Joint CMPA/USACE Application Supporting Documentation

Champney River Public Boating Access

McIntosh County, Georgia

SHEET: 8 of 17

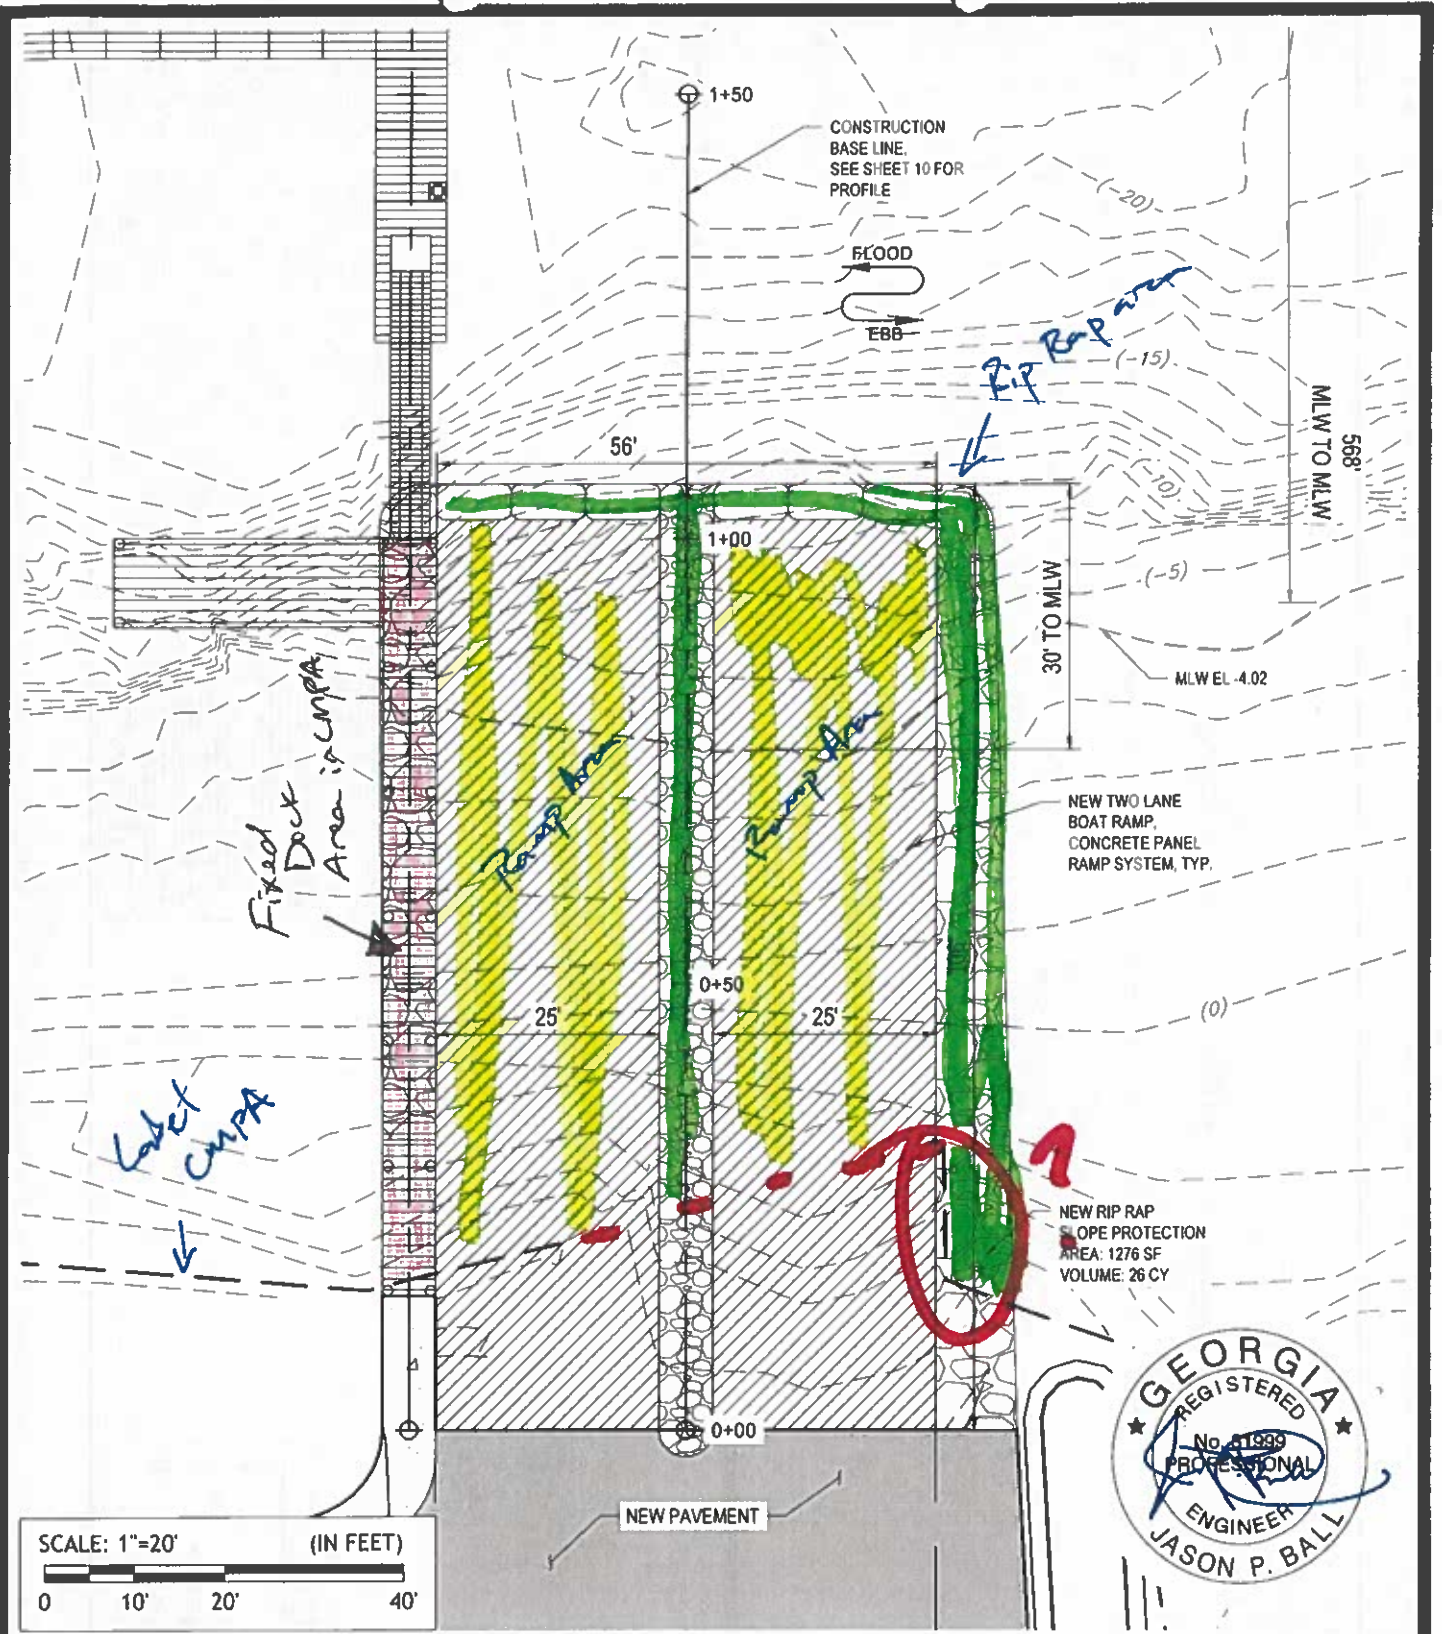
I've been in discussions with the permitting side some more and they are needing a bit more detail on areas for the ramp and dock. In the attachment, there are 4 different points for clarification, each a different color.

- First - In pink, we need to know the area of the fixed dock that is within CMPA jurisdiction. There is a small tab right at the upland where the CMPA line intersects the fixed dock. We need to delineate between upland and CMPA here. If you just want to provide the area that is not in CMPA, that may be easier to subtract from what we know to be the total square-footage of all the docks put together (we have calculated that already).

- Second - In green, we need to know the total square-footage of rip rap in CMPA jurisdiction, minus the area of the rip rap covered by the fixed dock (this impacted area is already accounted for with the dock).

- Third - Similarly, in yellow, we need the area of the ramps in CMPA jurisdiction.

-Fourth - This brings me to the final color, red, which may need to be the first, but I defer to you there. Permitting was perplexed to see the CMPA line not connected across the ramp, and by the circled angle of the CMPA line. For reference, the second page is the survey of the site, which shows a straighter line between the CMPA line on the east side of the ramp and the CMPA line on the west side of the ramp. This line will affect the area you provide for the ramp (yellow) at least and may also affect the fixed dock (pink) area in CMPA. Can you help connect the JD line across the ramp and then provide the areas for the other components in CMPA jurisdiction? Can you amend Page 8 of the drawings and send us the update?

1. Dock area in CMPA: 499 SF
2. RipRap area in CMPA: 1400 SF
3. Boat Ramp area in CMPA: 4160 SF
4. CMPA line has been corrected on all drawings

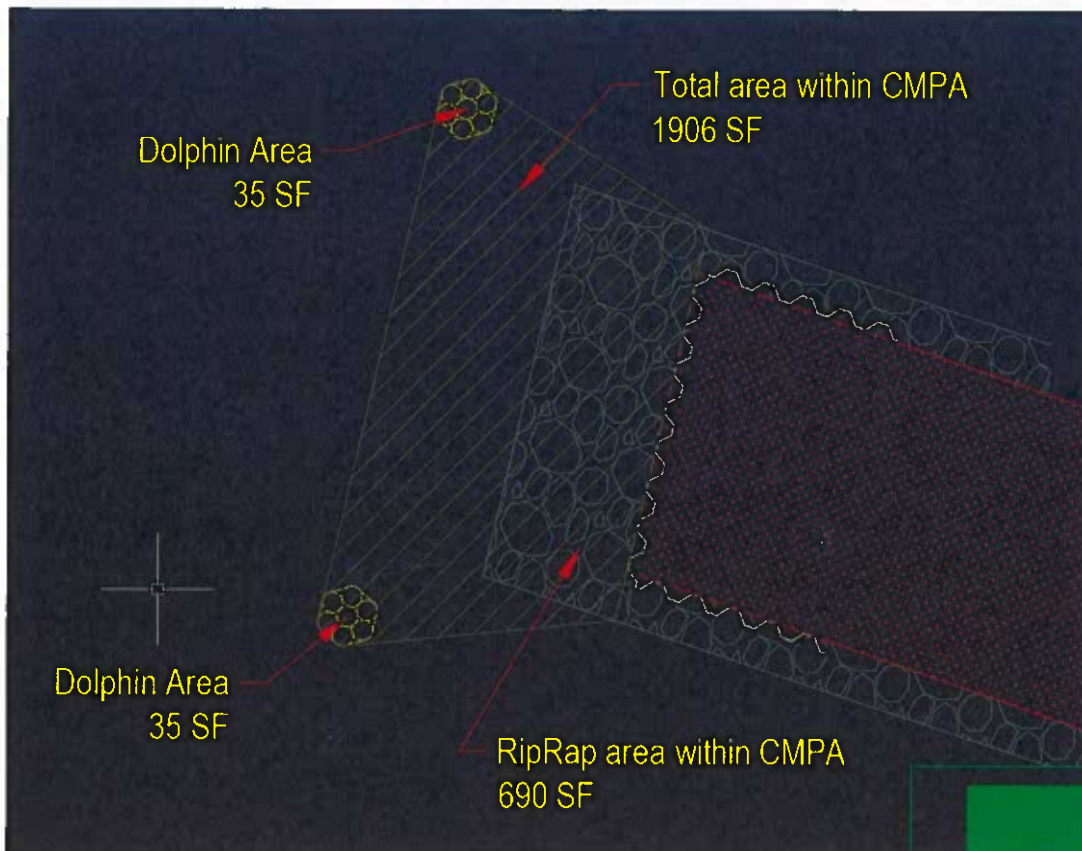
First, What is the total square footage of the barge landing, *including the dolphins*, that will be within CMPA jurisdiction? I got this question specifically from the permit coordinator reviewing the permit application.

1. Unsure exactly what they are looking for in terms of total square footage so see below for all possibilities.
